EMPIRE FLOODGATE

PERIODIC INSPECTION REPORT NO. 5

CELMV-ED-G (CELMN-ED-DG/15 Jun 87) 3d End Mr. Stegall/eb/5900
SUBJECT: New Orleans to Venice, Louisiana (Hurricane Protection); Reach
B-1 - Tropical Bend to Fort Jackson, Empire Floodgate, Periodic Inspection
Report No. 5, 29 January 1987

1. The enclosed periodic inspection report is approved subject to the following comment:

Photo No. 5: Deficient riprap (Typical)

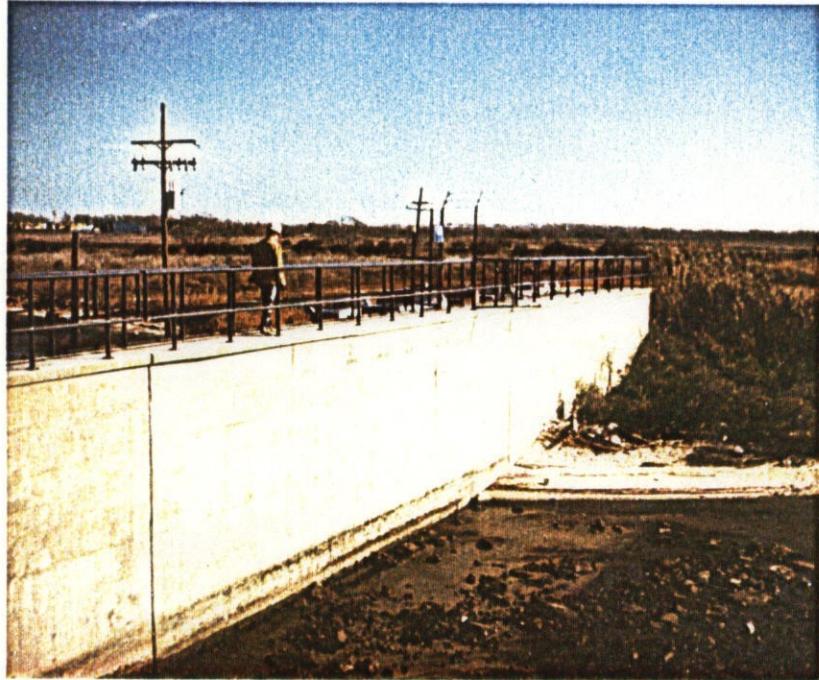
Paras 5-03 II and 6-02b. The riprap used to repair the damaged breakwater and also the approach channels should be designed, specified, and documented in this report. This will ensure that local interests will adequately repair these damaged areas.

b. Riprap is deficient all around the structure (See Photo No. 5). According to the plans there are areas near the T-Walls, sheet pile, levees and shoreline that require riprap up to elevation +8.00 feet and that seems not to be the case.

Paras. 5-03III and 6-02b. Concur. A 24-inch layer of No. 2 riprap stone
will be recommended for repairing the breakwater protection and the
approach channels in order to ensure that local interests will adequately
repair these damaged areas. See Encl 2.

*b. A 24-inch layer of No. 2 riprap stone will be replaced at the breakwater dike on the southwest bank and the east side of the north and south approach channels.
